Final CLOSEOUT REPORT

High Flux Beam Reactor Underground Utilities Removal Area of Concern 31

EPA Comments on DRAFT HFBR UNDERGROUND UTILITIES CLOSEOUT REPORT July 2011

NYSDEC Comments on DRAFT HFBR UNDERGROUND UTILITIES CLOSEOUT REPORT July 2011

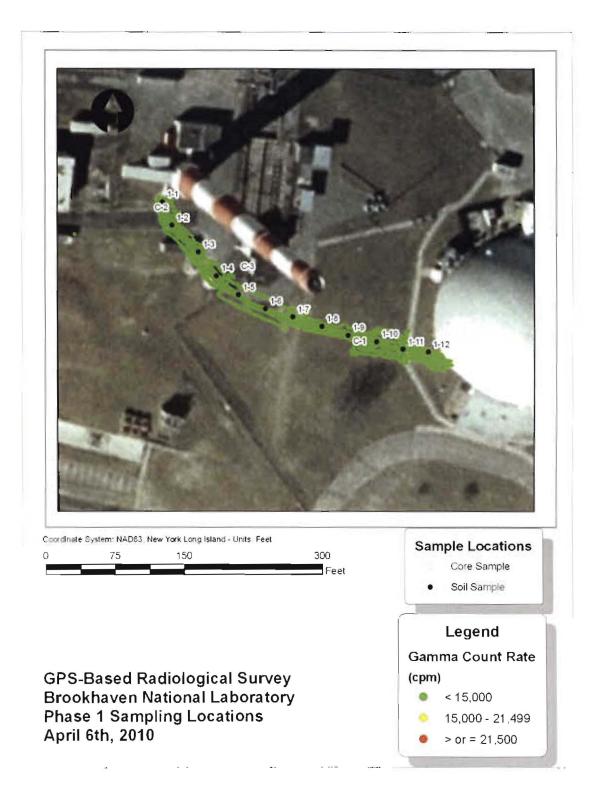
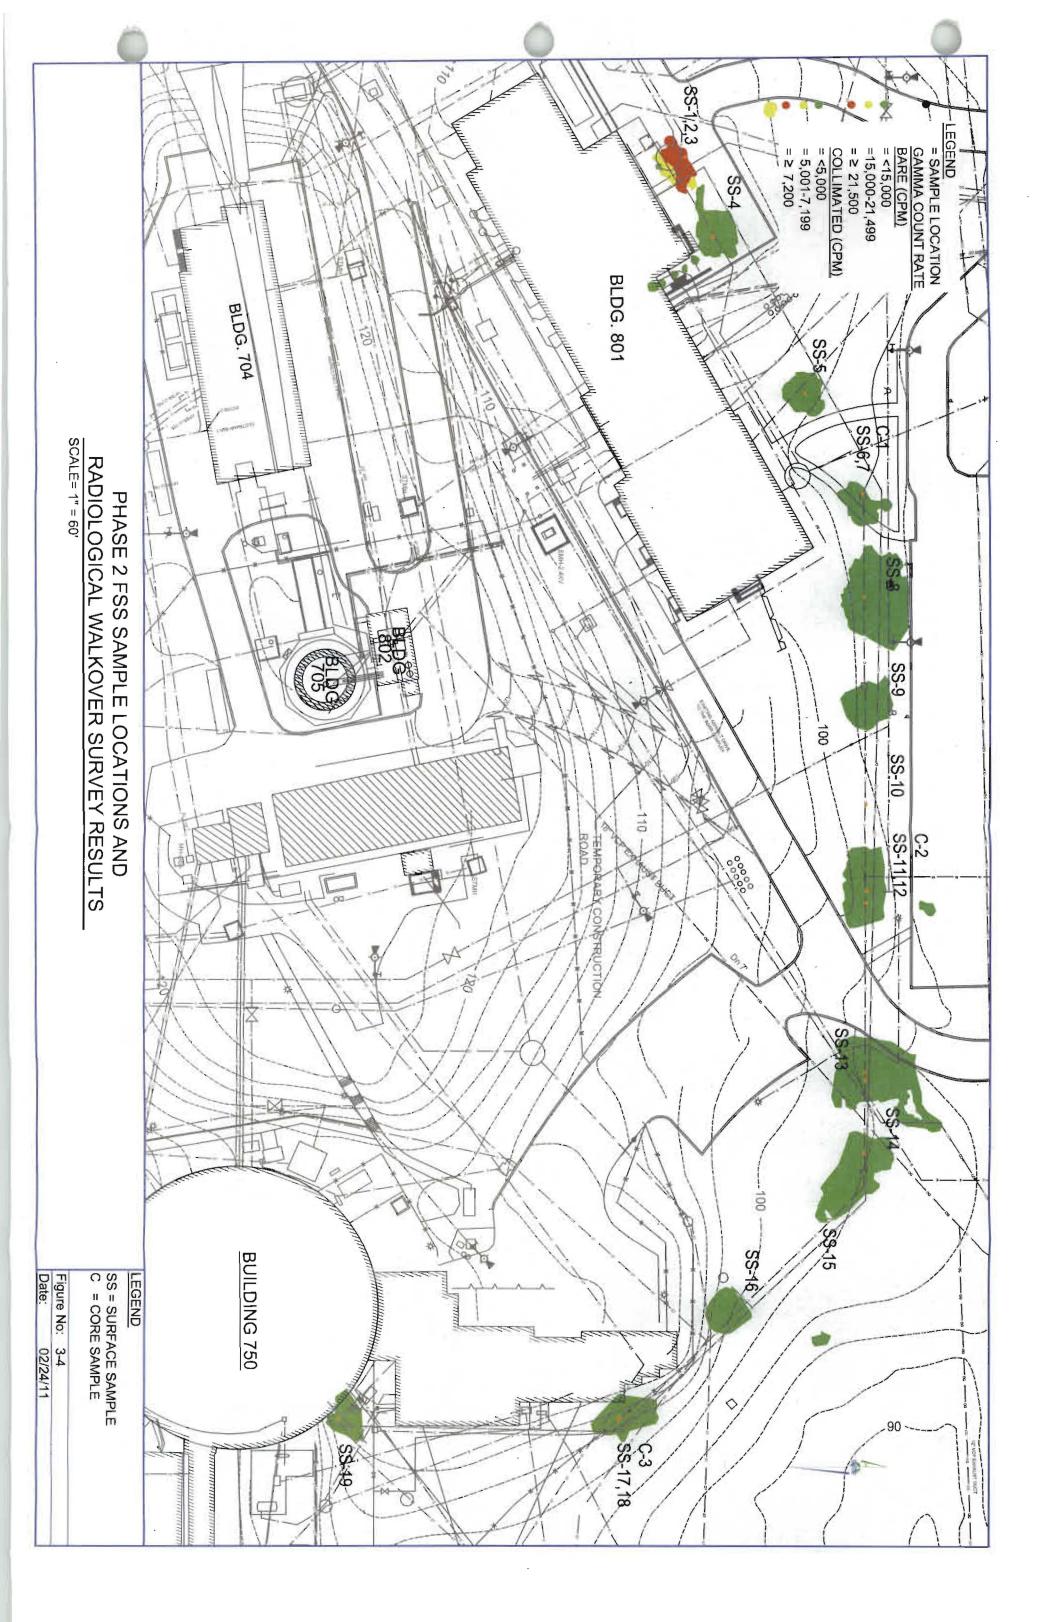
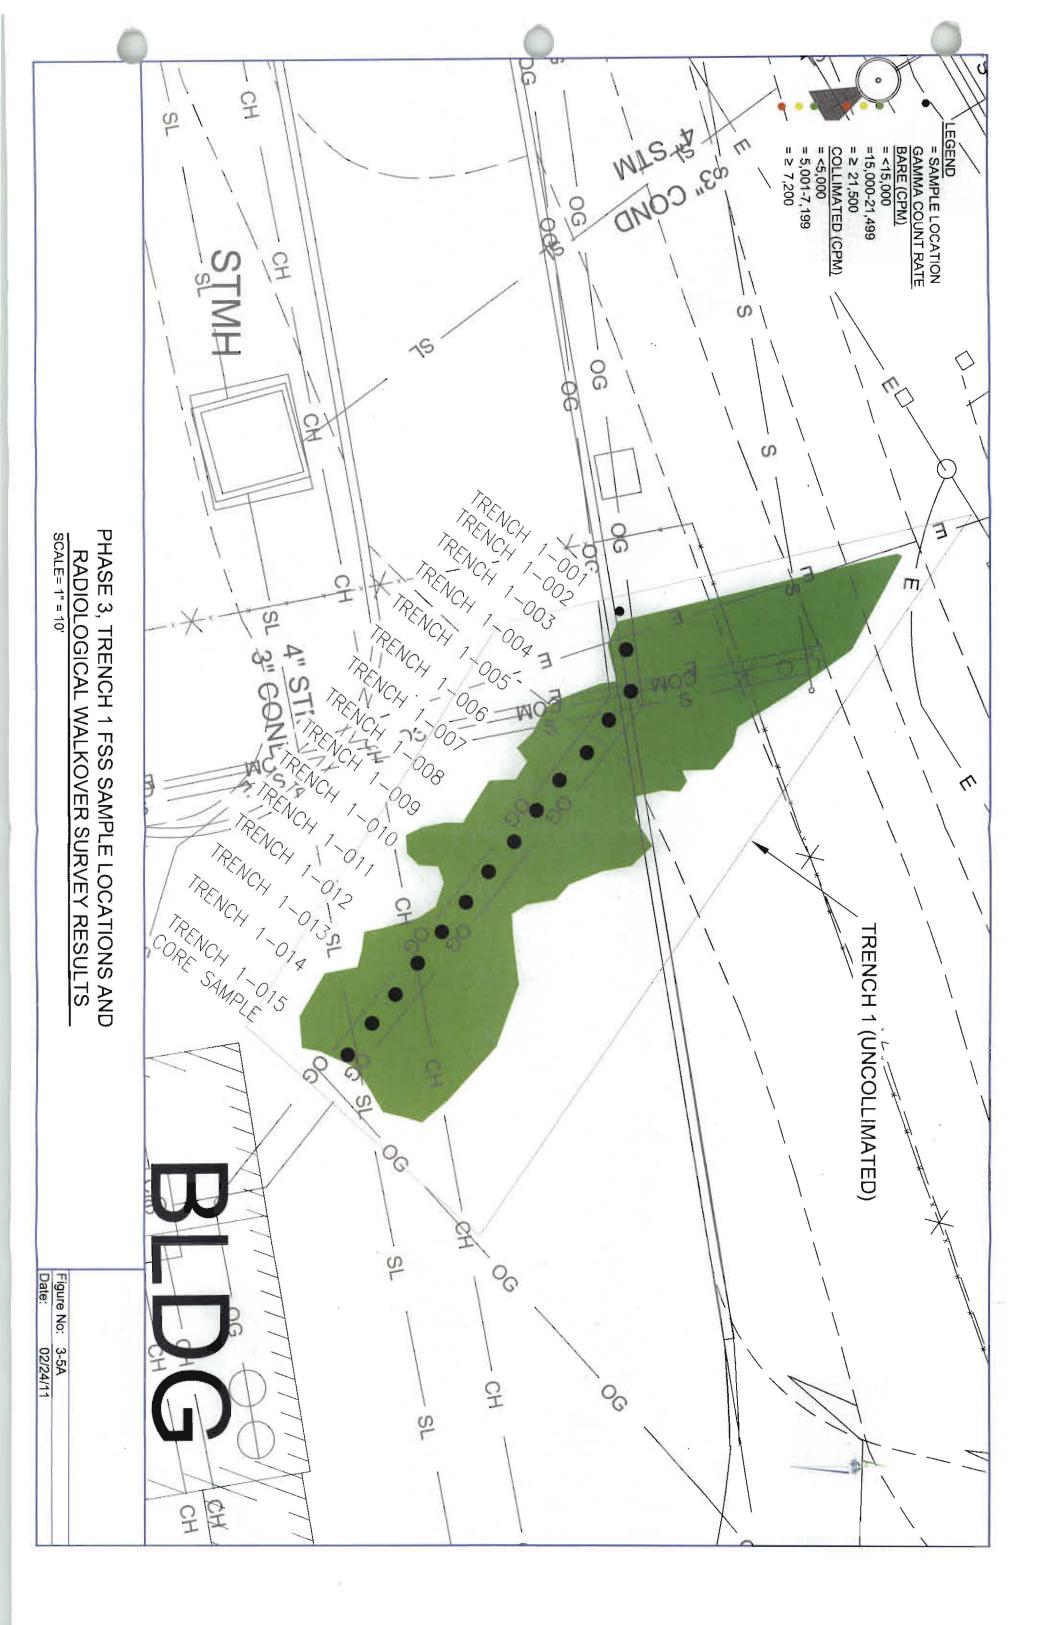
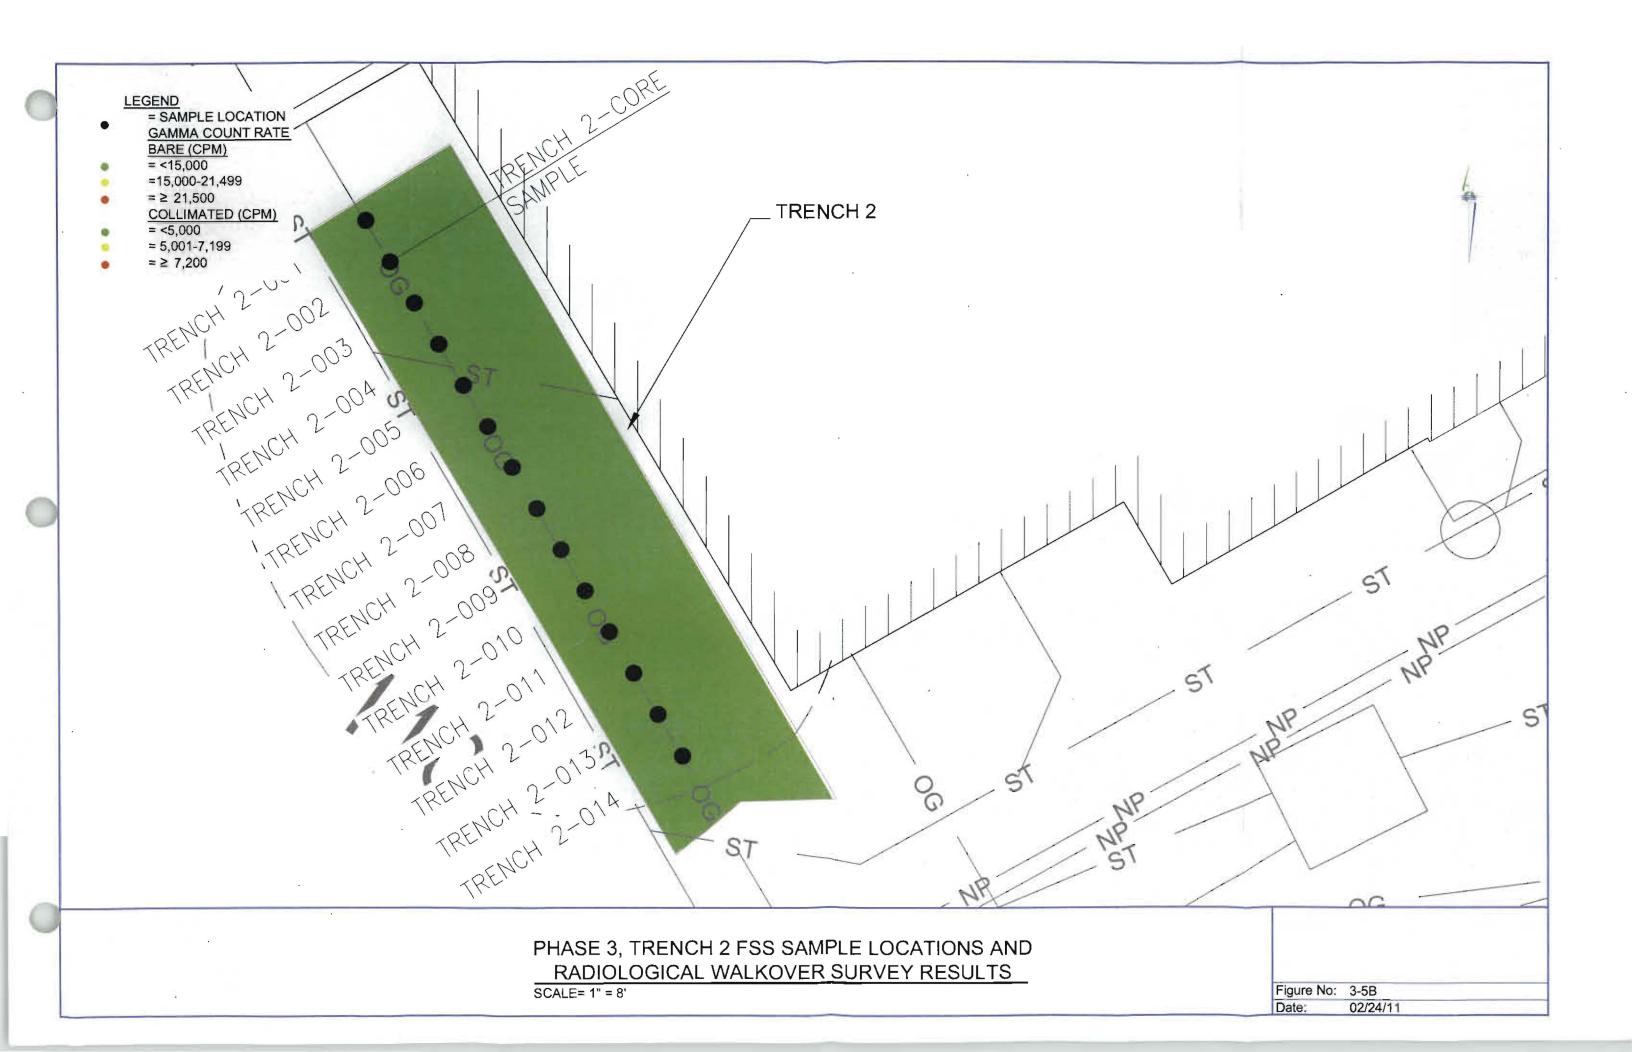
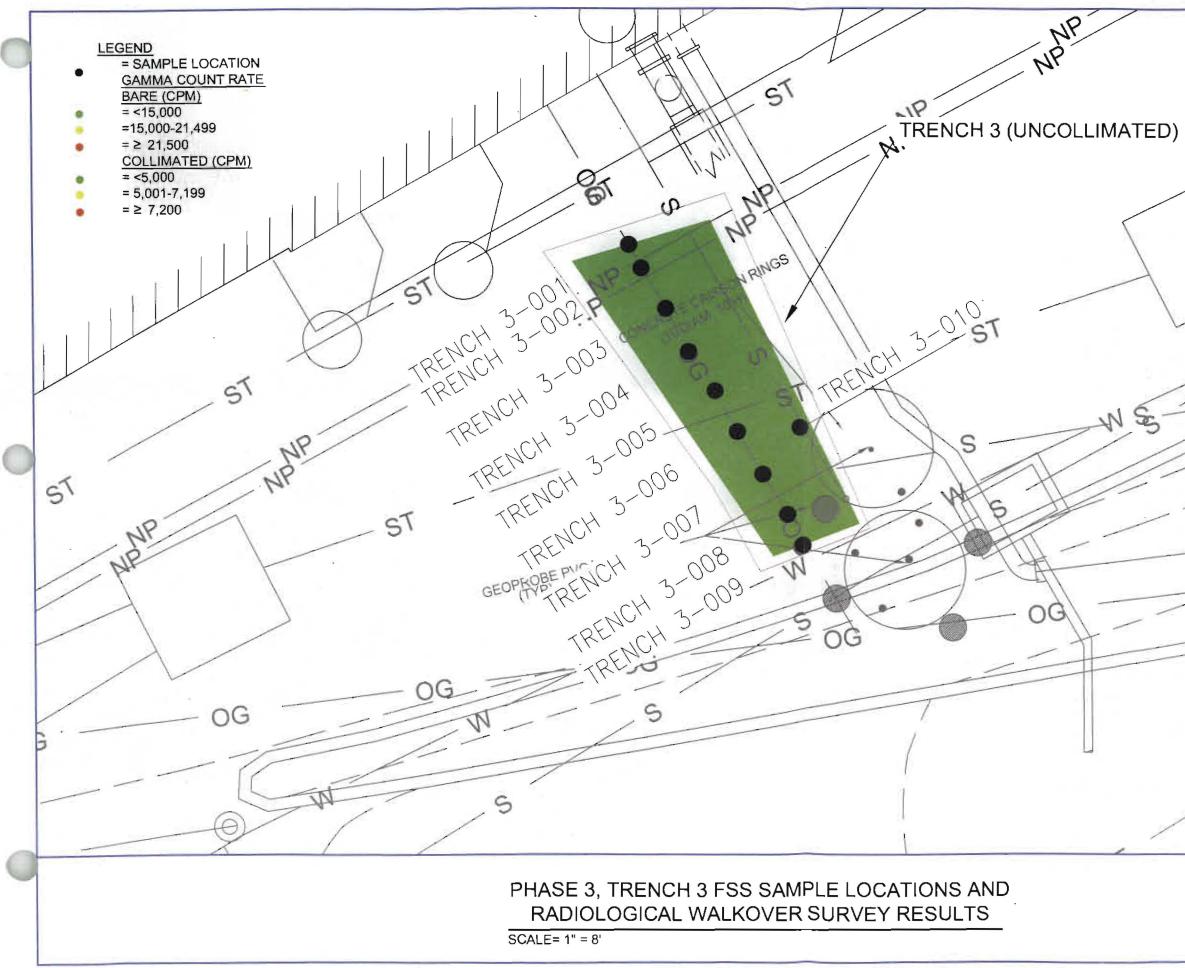
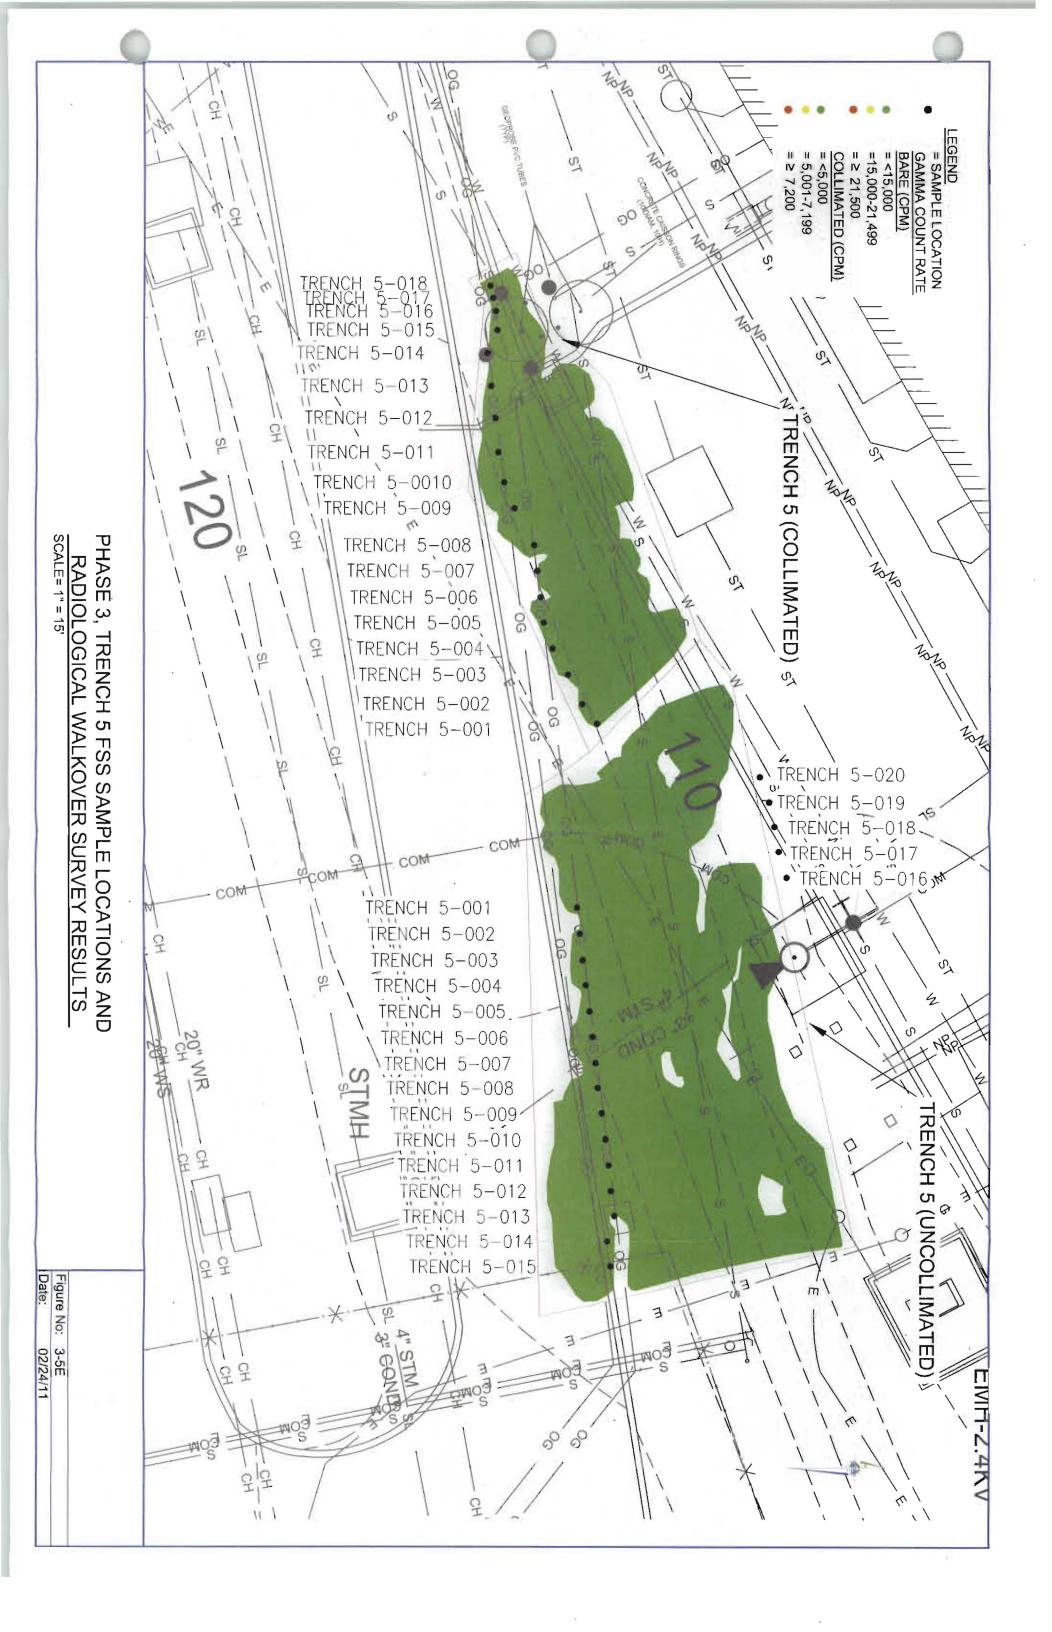
DEC-03	Section 3.2.2, Page 22: "As shown in Figure 3-2, an isolated area" Figure 3.2 should be corrected to read Figure 3-4.	Revised as suggested.
DEC-04	Figures 3-4, 3-5A, 3-5B, 3-5C, 3-5D, 3-5E: The legend for the gamma count rate should be included in each of the figures.	Revised as suggested
DEC-05	Table 3-2, Page 30: This table states that "No samples indicated detectable values" for Sr-90. The table should indicate what the detection limit was for this analysis.	The detection limit for Sr-90 is approximately 0.8 pCi/g. The table was revised accordingly.
DEC-06	Table 3-2, Page 30: The note states that "Other radionuclides as listed in Table 3 of the FSP were analyzed for, and no detectable concentrations" It should be made clear that the detection limit is less than the site cleanup goals listed in Table 2-1.	The note was revised to indicate that detection limits for radionuclides in Table 3 of the FSP are less than 20% of their respective cleanup goals.
